E1-24 Part III

IWUIC: A103.2, TABLE C101.1, G101.3.2

Proposed Change as Submitted

Public Comment GROVE-PC1:

Horizontal Exit

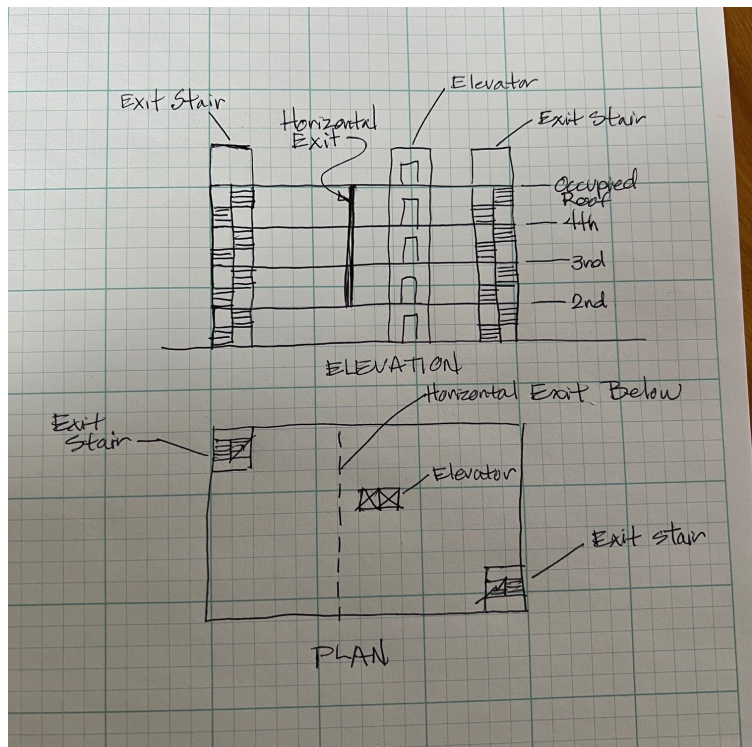
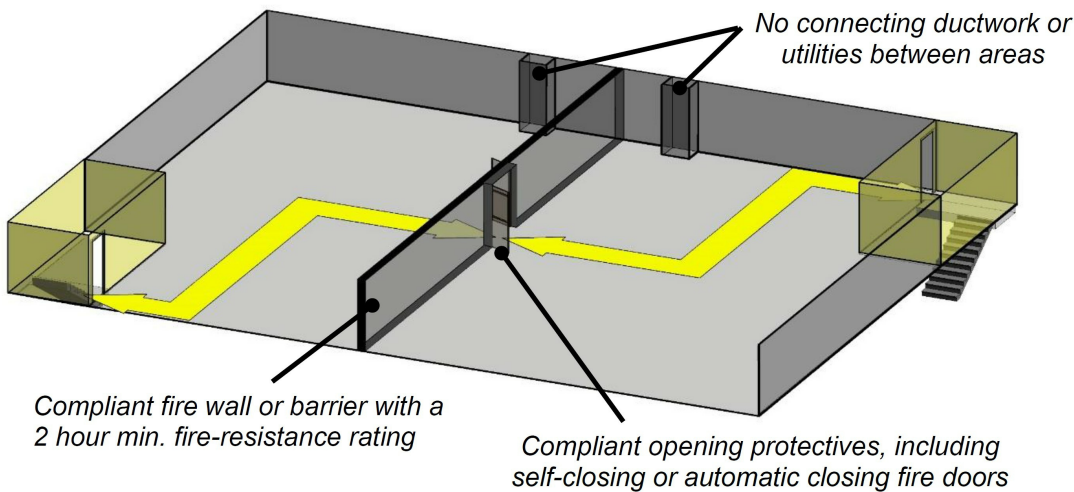
1009.2.1 Exception 1 - The current exception allows for buildings 5 stories or taller to not provide standby power to the elevator where each floor has a horizontal exit. The horizontal exit provides for giant area of refuge that protect occupants from smoke and fumes so that there is more time allowed for self and assisted evacuations. In this situation, standby power is not required at 5 stories, but there is not a similar exception for fire service access elevators at 120'. So no stand by power with horizontal exits is basically an option for buildings between 5 and 12 stories tall.

Below is a diagram (courtesy of US Access Board) of a horizontal exit that shows why areas of refuge are not required.

Following that is a sketch showing a plan and elevation for a building with horizontal exits on each floor above the level of exit discharge.

Horizontal Exit

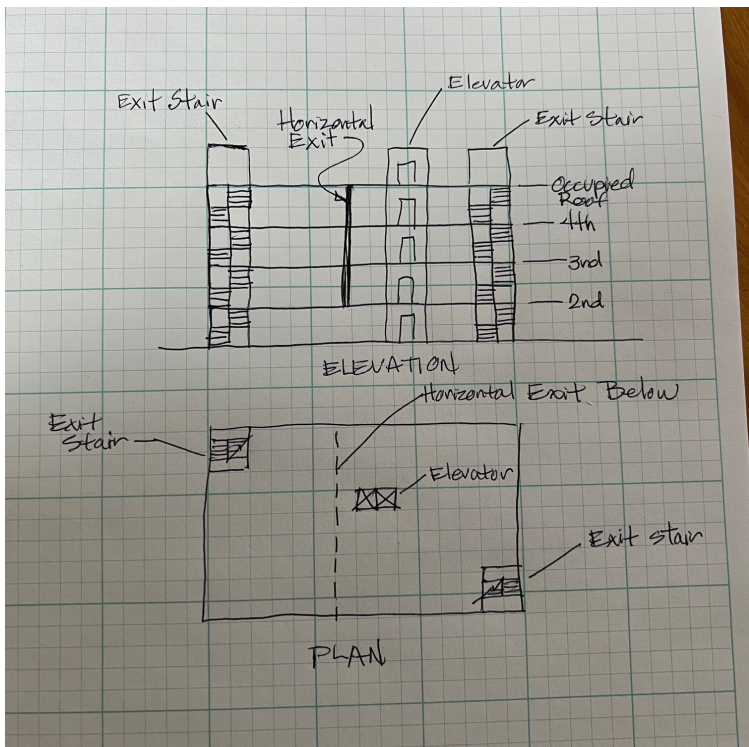
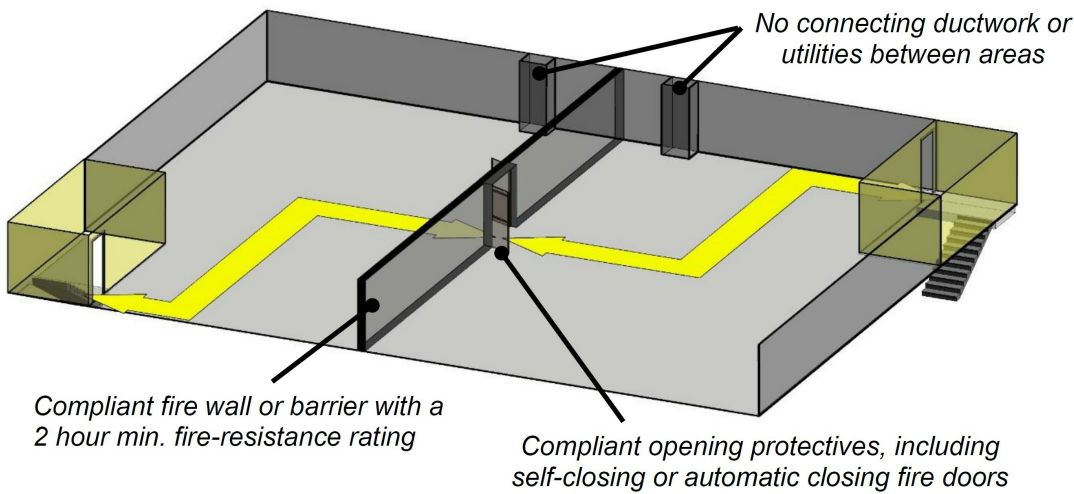
1009.2.1 Exception 1 - The current exception allows for buildings 5 stories or taller to not provide standby power to the elevator where each floor has a horizontal exit. The horizontal exit provides for giant area of refuge that protect occupants from smoke and fumes so that there is more time allowed for self and assisted evacuations. In this situation, standby power is not required at 5 stories, but there is not a similar exception for fire service access elevators at 120'. So no stand by power with horizontal exits is basically an option for buildings between 5 and 12 stories tall.

Below is a diagram (courtesy of US Access Board) of a horizontal exit that shows why areas of refuge are not required.

Following that is a sketch showing a plan and elevation for a building with horizontal exits on each floor above the level of exit discharge.

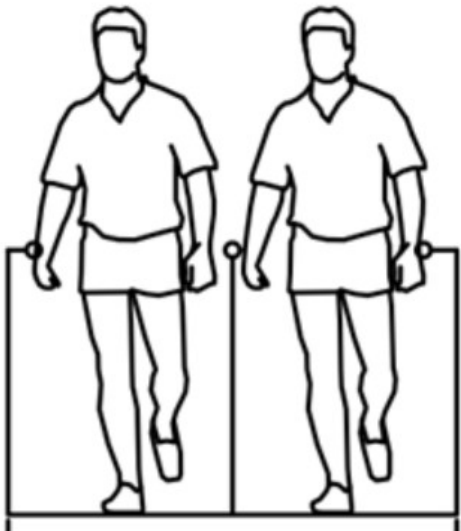
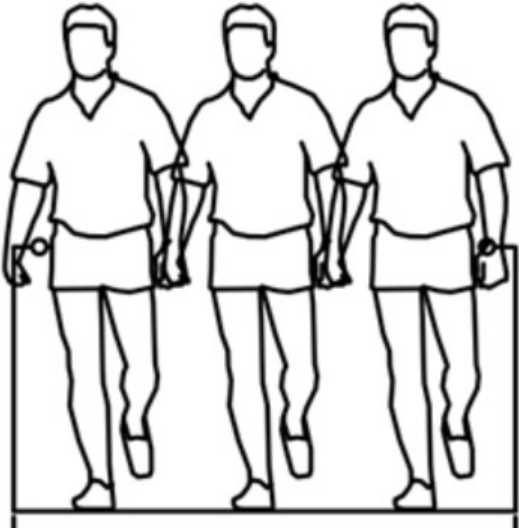
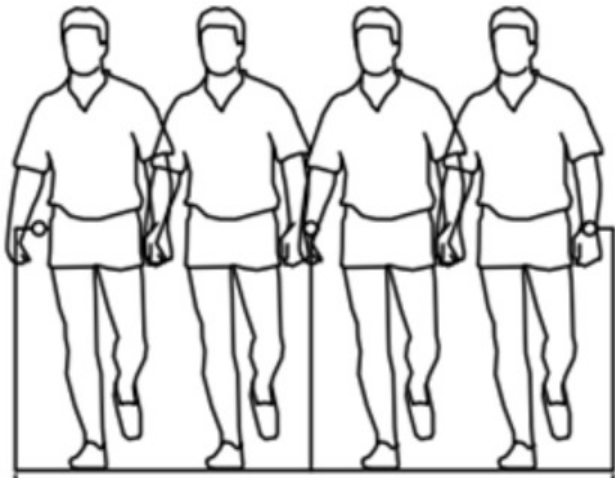
The concern is, that when the required and actual width is 60-inches to 88-inches, a center handrail could actually be an obstruction for the occupants that were trying to egress.

There were studies done on stepped aisles with a center handrail in stadiums used for the Olympics when they were held in Canada. This is the basis for the 30-inch maximum reach for handrails in order to arrest a fall. However, there needs to be a balance between reach for the handrail and sufficient capacity for the stairway. (Note that this requirement is not tied to distance between handrails because handrails can be over the stairway, over the stringer, or even outside of the stairway.)

Based on the 44-inch corridor width, we are assuming a minimum of 22 inches is required for persons to pass each other or walk side by side. So for three people to walk down a stairway side by side, you need 66 inches; and for four people you need 88 inches. See examples below.

Example of 60 inch required width stairway with current required center handrail.

Example of 66 inch width stairway required for large capacity egress without a center handrail.

The proposed comment will allow for a wider stairway before requiring an intermediate handrail. This will allow for savings by eliminating the cost to fabricate/install the intermediate handrail for stairs with a required egress width between 60" and 88".

Commentary Figure 1028.2(1)
PROTECTION OF LOBBY WITH AN EXIT DISCHARGE

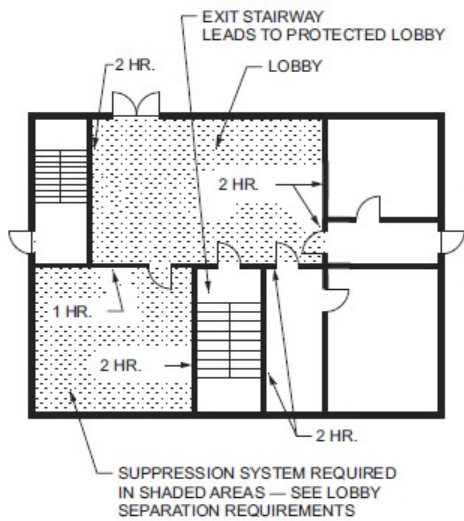
Reason: E111-24 was disapproved in CAH1 because the committee felt that asking for the entire first floor to be rated instead of just the floor under the lobby used for exist discharge was not necessary. The committee had it right the first time.

The modification in CAH2 not only requires the entire story over a basement to be rates, but could be interpreted to require the entire floor to be rated over a crawl space or open area where a building is raised for flood or parking. The added phrase "or useable areas below" is too open for interpretation to be good code text.

We are requesting disapproval and asking the membership to move the text back to the way it was in 2024 IBC and IFC. Below is the figure from the commentary. A fire under other portions of the floor would not have a hazard to the lobby. It is also important to note that this could be a building of a substantial size, with the lobby being a very small portion of the footprint of the building.
